INDEX OF SHEETS		SHEET No.
TS01	TITLE SHEET	01
GN01	OVERALL SHEET KEY	02
GN02	GENERAL NOTES	03
RD01-RD07	ROADWAY PLAN & PROFILE	04-10
SDGN01	STORM DRAIN SHEET KEY	11
SDGN02	STORM DRAIN GENERAL NOTES & DETAILS	12
SD01-SD05	STORM DRAIN PLAN & PROFILE	13-17
DFGN01	DETENTION POND GENERAL NOTES	18
DF01-DF04	DETENTION POND 1 SITE PLAN	19-22
WT01	WATER CISTERN PLAN & DETAILS	24

HAY CREEK VALLEY

CONSTRUCTION DOCUMENTS

SEPTEMBER 2023

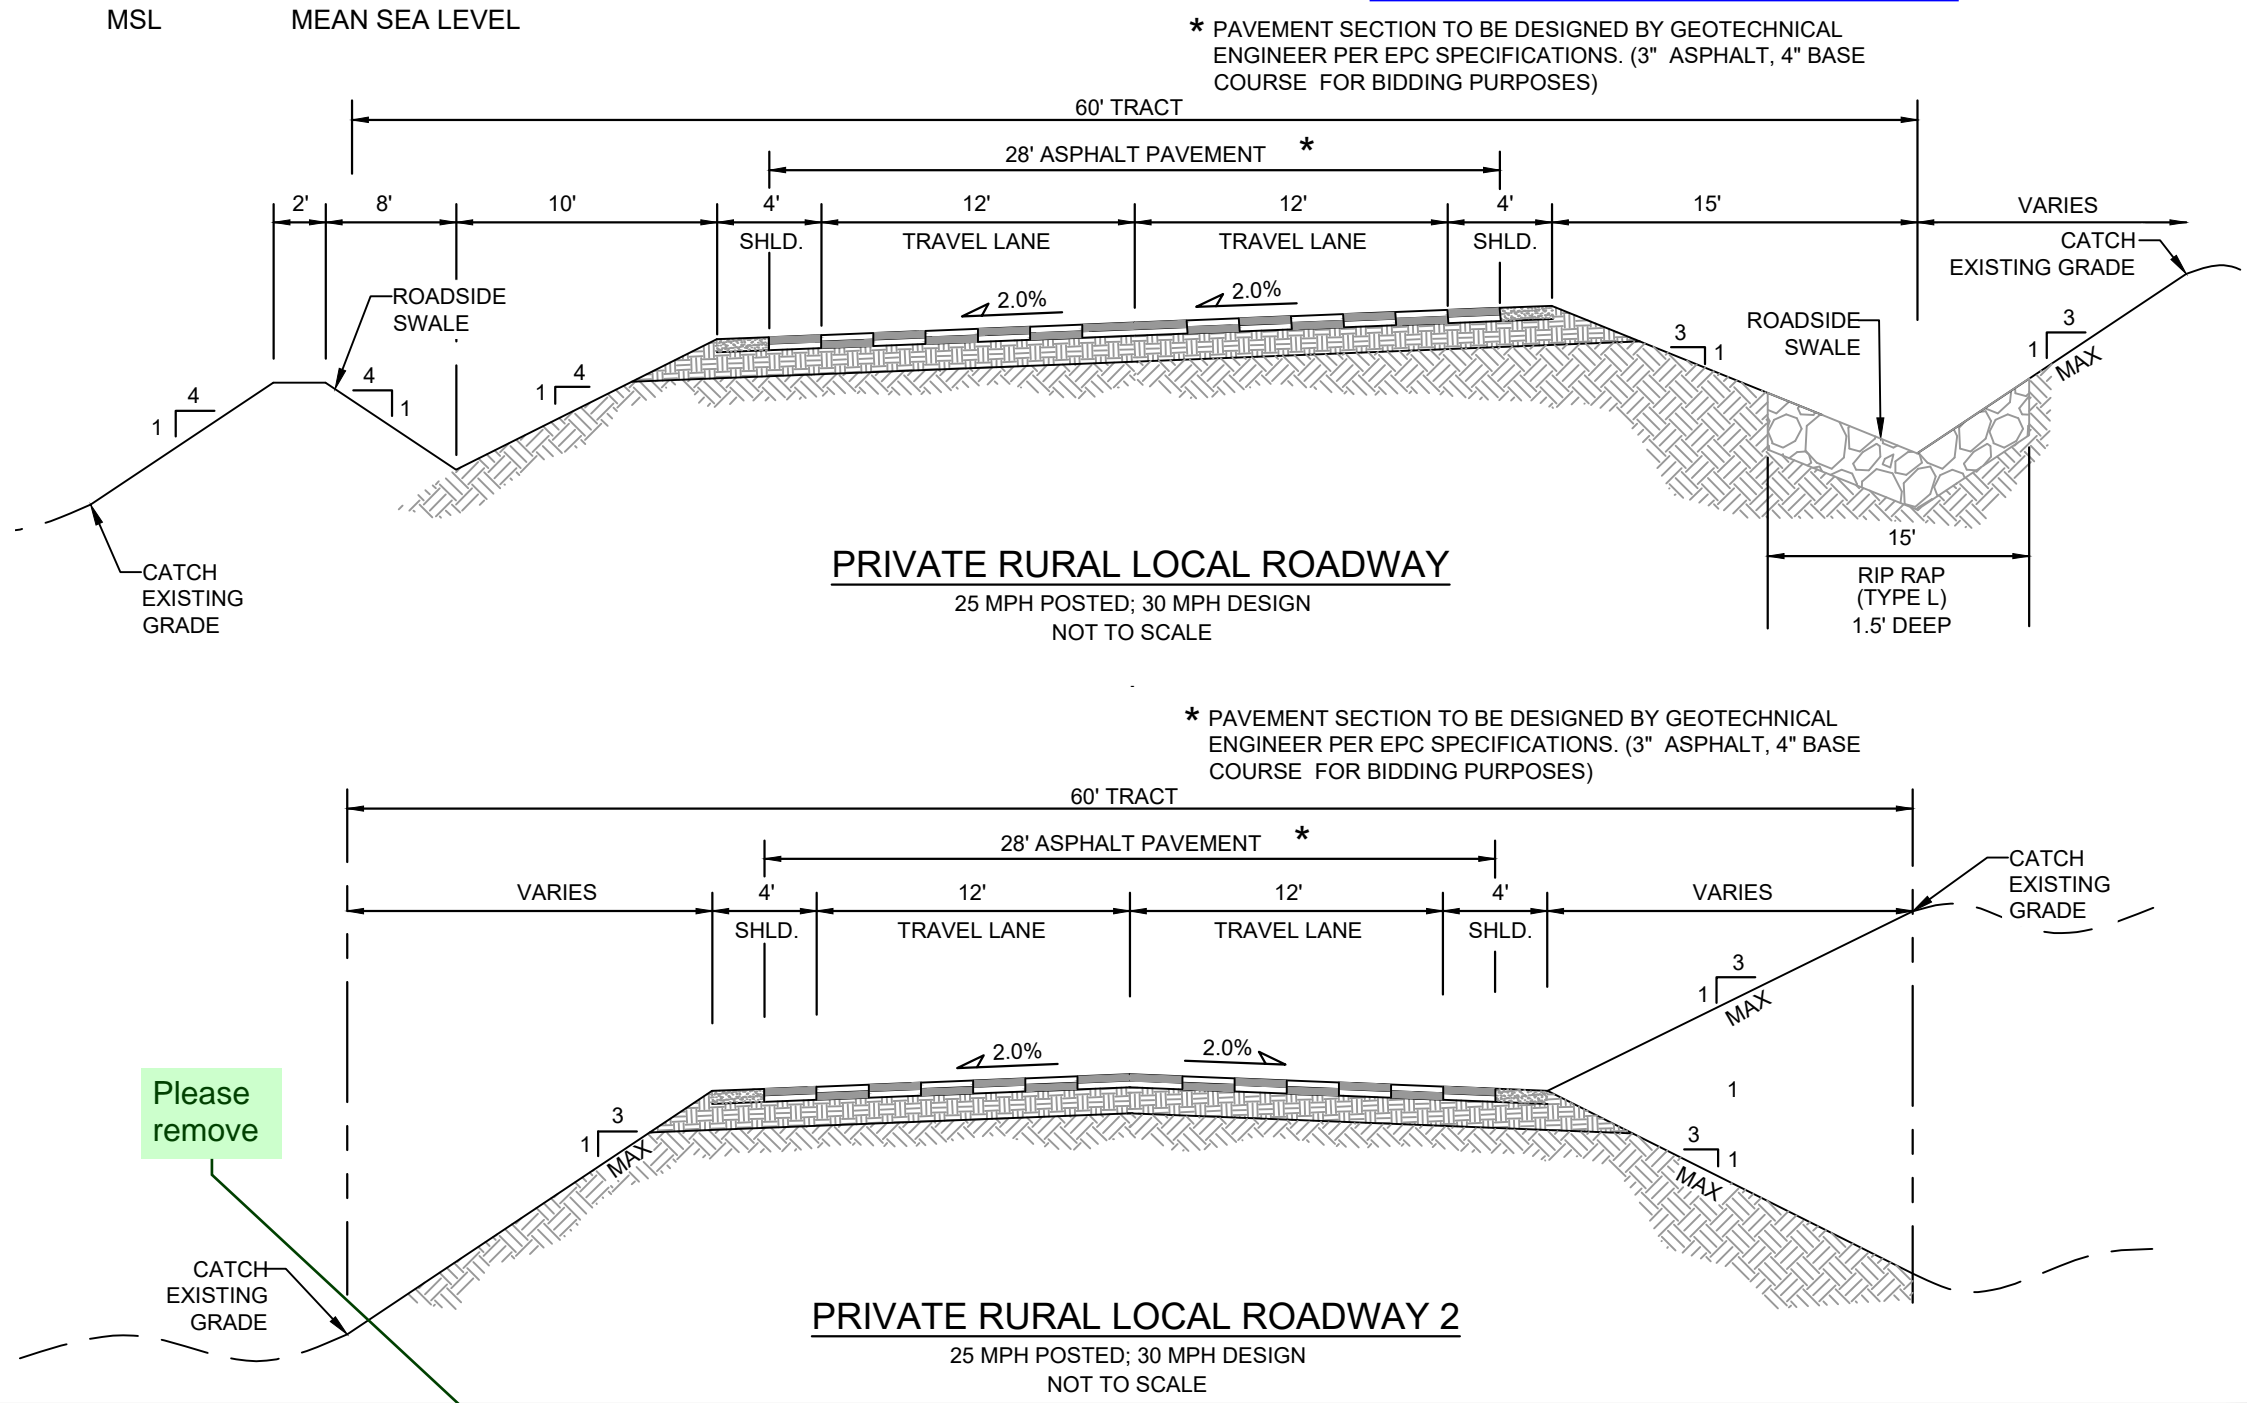
Are there 5ft easements for 70ft shown on Plat? Call out easement width as applicable. Review the PRELIM Plan

WHITE BEAR POINT ROAD PROFILE 4 SCALE: (H) 1" = 40' (V) 1" = 8' START STA: 33+50.00, END STA: 44+00.00

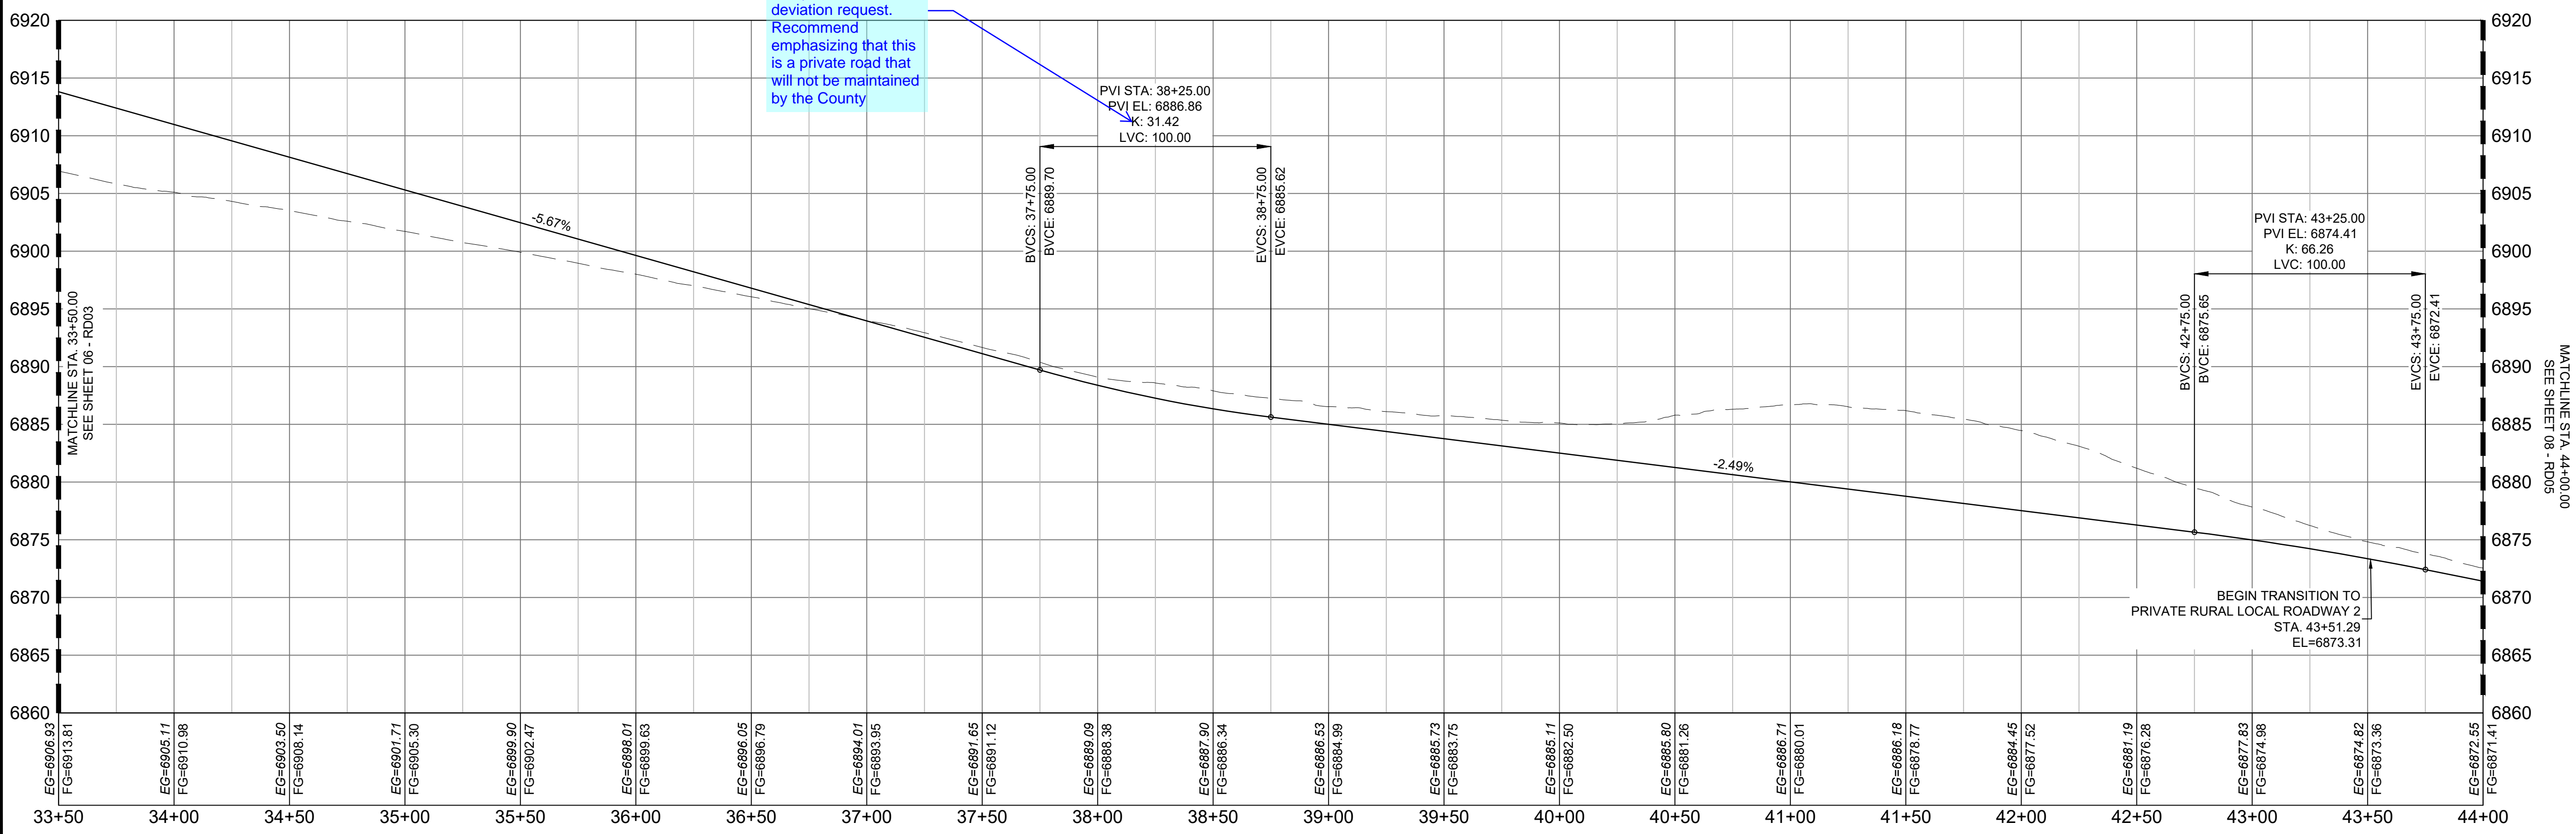
K value does not meet ECM criteria for sag vertical curve (min. K-37 per Figure 2-20). Submit a deviation request. Recommend emphasizing that this is a private road that will not be maintained by the County

WHITE BEAR POINT ROAD PROFILE 5 SCALE: (H) 1" = 40' (V) 1" = 8' START STA: 44+00.00, END STA: 56+00.00

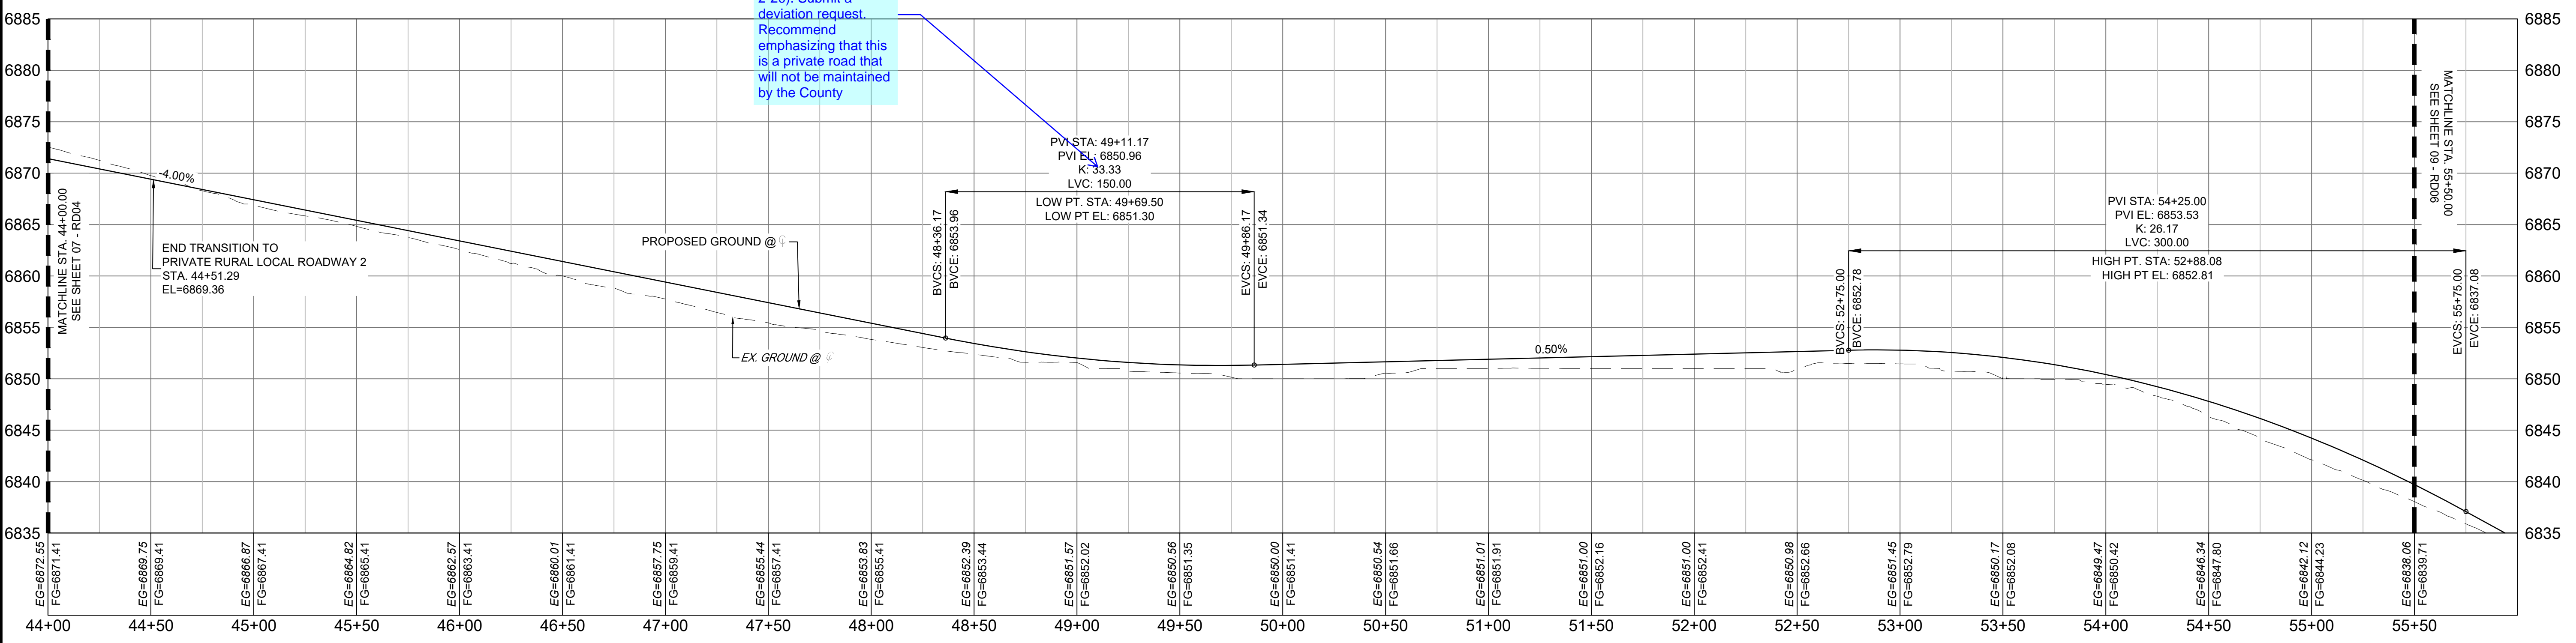
K value does not meet ECM criteria for sag vertical curve (min. K-37 per Figure 2-20). Submit a deviation request. Recommend emphasizing that this is a private road that will not be maintained by the County
